FAIRFAX COUNTY PLANNING COMMISSION

**PUBLIC HEARING
FOR
PLANNING DETERMINATION**

Application Number: **2232A-MD06-10-1**

Proposed Use: Sunset Hills Road & Dulles Airport Access Road Traction Power Substation (TPSS)

PROPOSED LOCATION LANDSCAPE PLAN

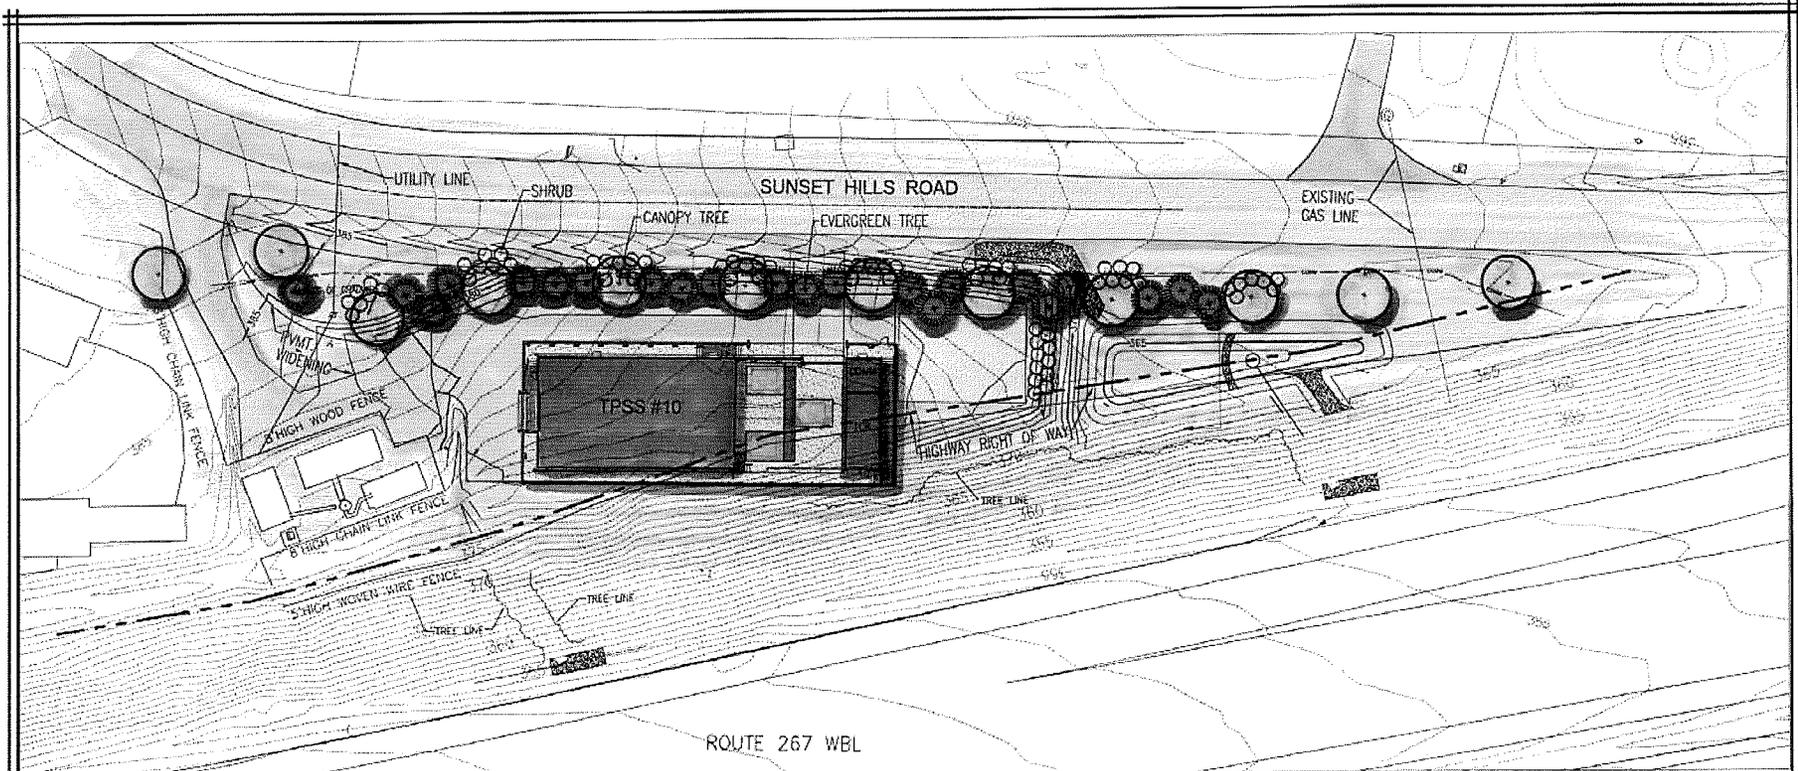
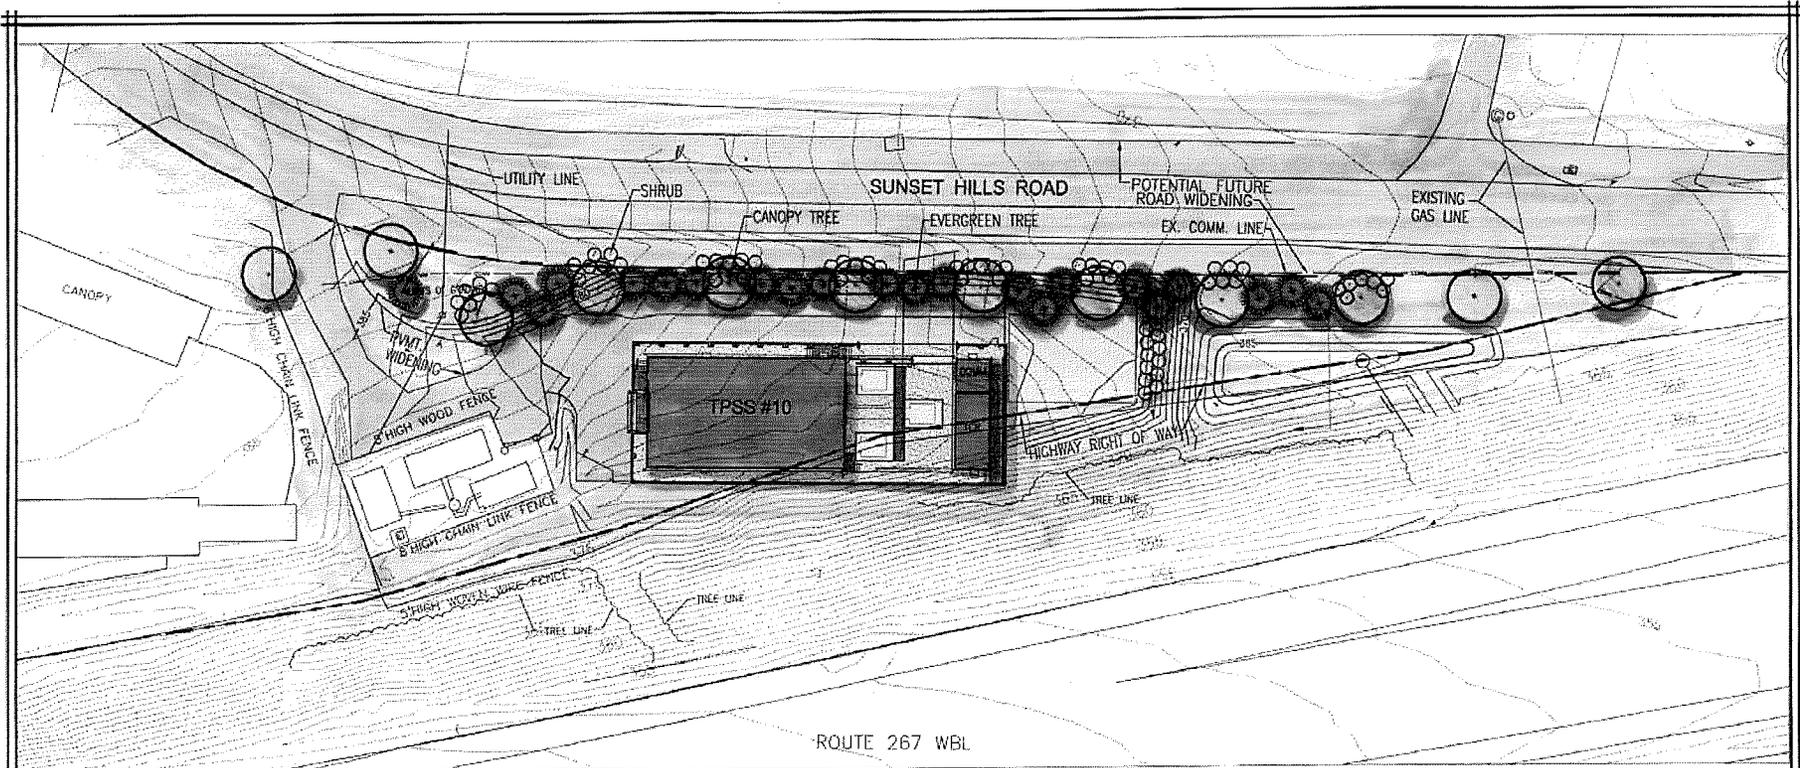
- Comment:** The proposed landscape plan shows northern bayberry and scarlet leucothoe for shrub planting in the transitional screening yard along Sunset Hills Road. Northern bayberry requires full sun. Scarlet leucothoe grows to only about 2 to 3 feet tall, so is not effective as a screen. Shrubs between Sunset Hills Road and proposed trees will need to be tolerant of shade to perform well beneath proposed large deciduous trees and grow to at least 5-6 feet tall to effectively screen the site. Shrubs could be planted on the site side of proposed deciduous trees where they would get more sun and would still be in a position to screen the substation.

- Comment:** Potential Sunset Hills Road widening would result in the loss of a significant number of the shrubs proposed for the screening yard. Appropriate shrubs could be planted further from the road and retained with potential road widening.

Recommendation: Show proposed shrubs located further from the road. Shrubs could also be planted on both sides of the screening yard as suggested above.

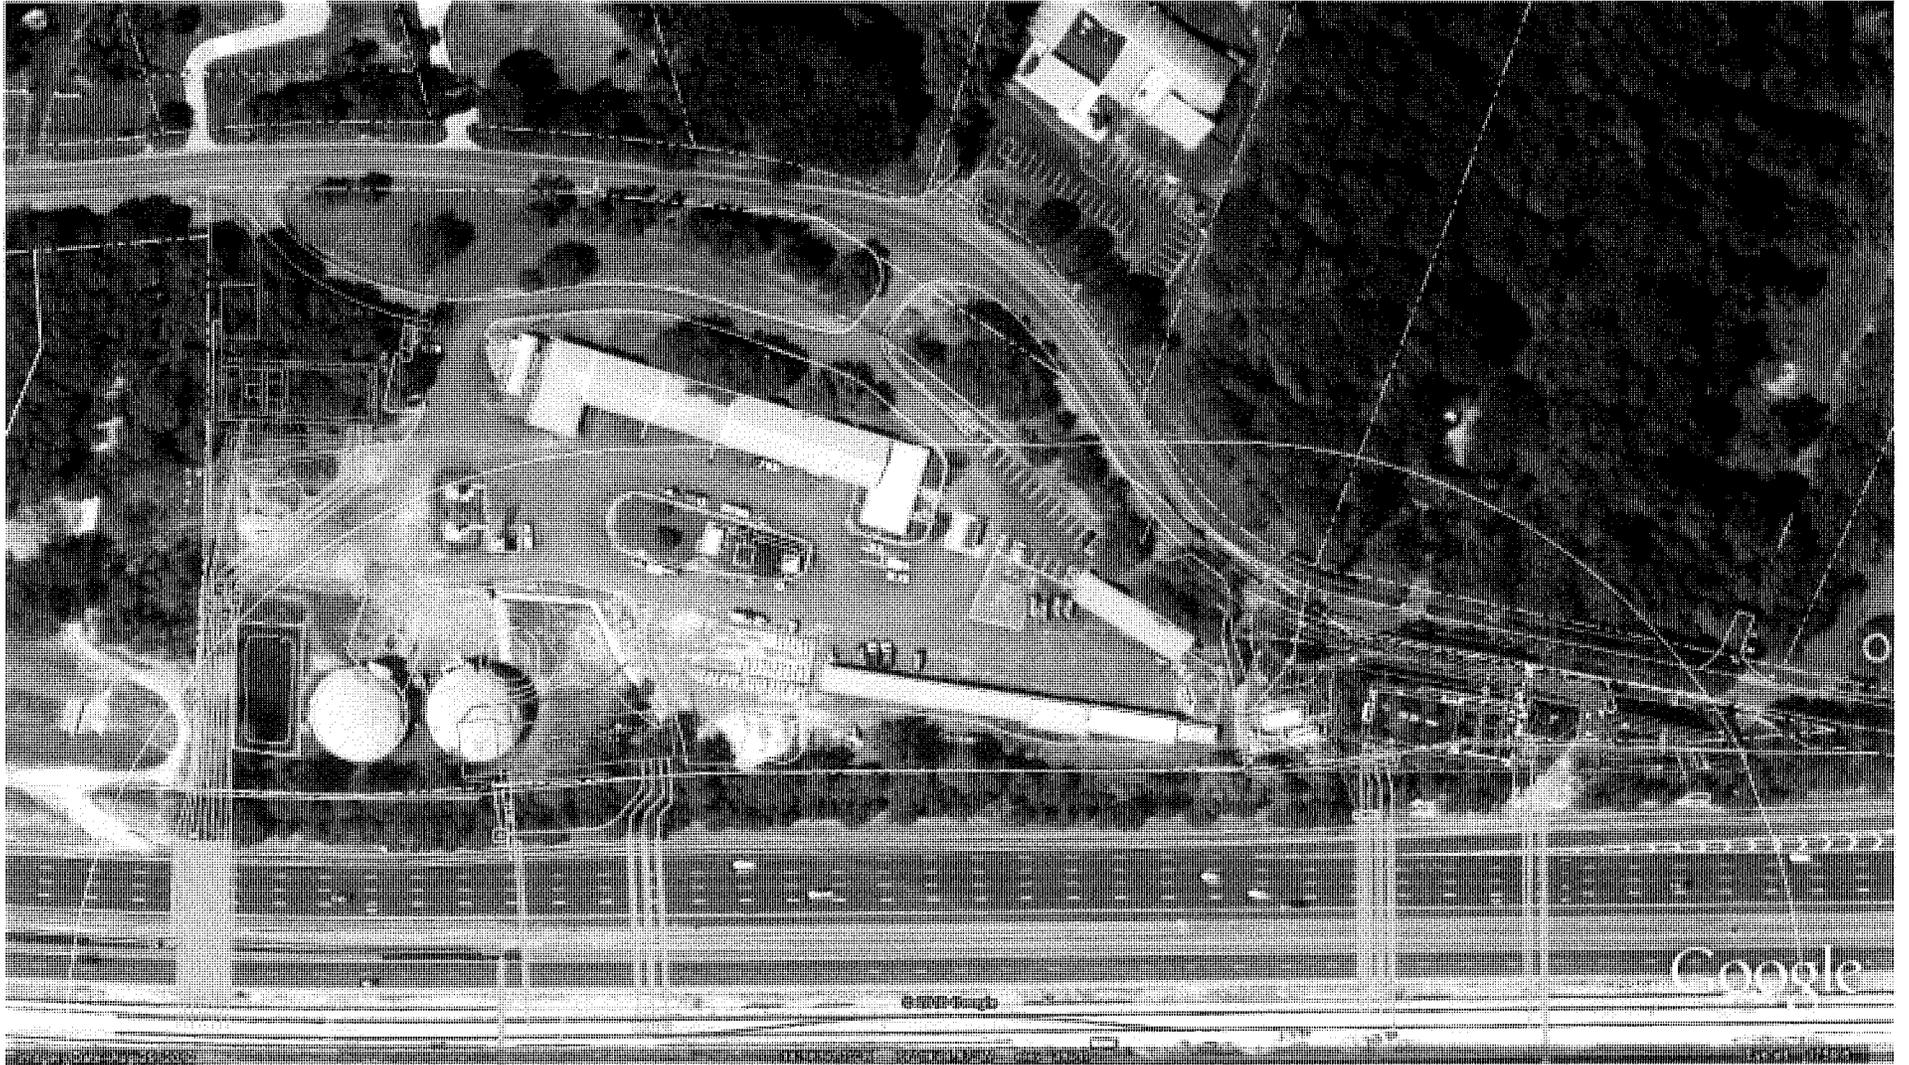
4. Graphic: Attached is an aerial photograph that was submitted with the application. The eastern red lined area is the proposed location. The western red lined area is the only other location offered by VDOT as an alternative. The yellow lined area in the middle of the two is the approved location. As stated in the Written Statement, the alternative was deemed not feasible because of the extended distance between the location and the tracks in the median of the DAAR, the need to run ductbanks and cables through the VDOT yard and potentially impact existing underground utilities and drainage lines, the lack of visibility from the location to the tracks, and the fact that the location is within VDOT's yard causing security concerns.
